Groundwater Transfer Review Summary Form

Transfer/PA # T- 14450

Application: T-14450

Applicant Name: City of Banks

Cross-section : W-E, proposed APOA “AN Well” and WASH 79189

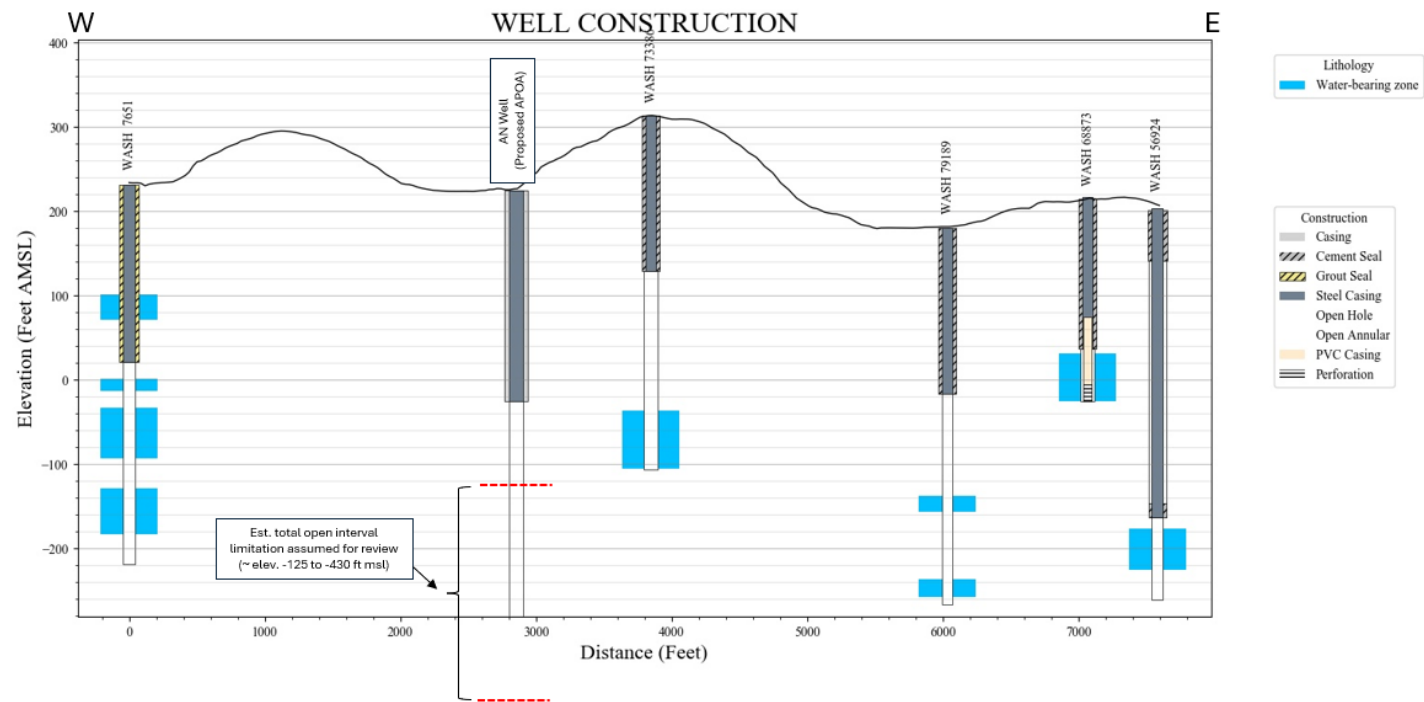
In lieu of evaluating injury potentially caused by all six of the proposed APOA, a likely “worst case” scenario was instead evaluated. This scenario consists of pumping from the proposed “AN Well” location, which is relatively near to existing wells that obtain groundwater primarily from common WBZ: WASH 79189 and WASH 56924 (see attached cross-section). Furthermore, because the same “AN Well” location (as well as WASH 62373) was also proposed as an APOA in transfer application T-14449, that well could be authorized to pump a stacked rate of 1.67 cfs (equal to 0.67 cfs from T-14449/permit G-7593, plus 1.0 cfs from this application T-14450/certificate 95849).

Relative to the location of authorized POA WASH 62373, the proposed location for the “AN Well” is about 2700 feet nearer to WASH 79189. The results of the Theis interference analysis indicates that additional interference in WASH 79189 could potentially range from about 10 to 50 feet due to pumping the *stacked* maximum rate (1.67 cfs) 24/7/365 from the “AN Well” (see attached Theis analysis results).

Theis Drawdown Analysis, Authorized POA WASH 62373 to WASH 79189

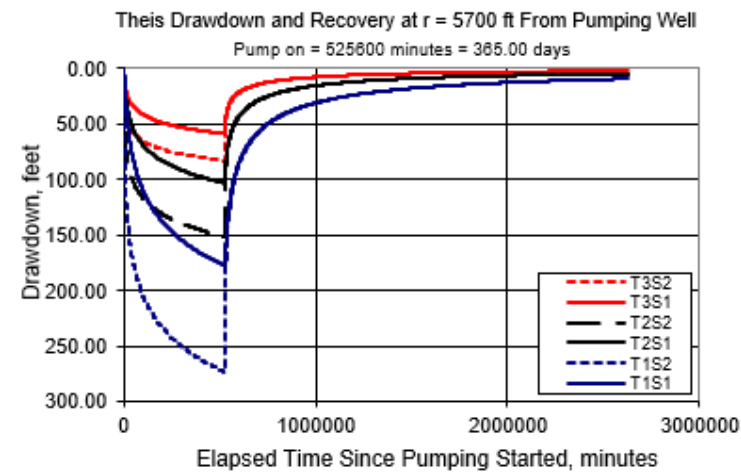
The results of the potential injury evaluation suggests that relatively moderate (~10-50 feet) levels of additional drawdown might be imposed in some area wells due to pumping of the “AN Well”, and possibly at other proposed APOA locations. It should be noted, however, that these estimates were completed using very conservative operational parameters for the Theis analytical drawdown method: pumping a single well at the full allocated rate (and in this case a stacked rate) for 24 hours a day, 7 days a week, 365 days a year. Actual pump operation will likely not be this sustained, and/or could be rotated to different locations to distribute overall pumping stresses to the CRBG aquifer system.
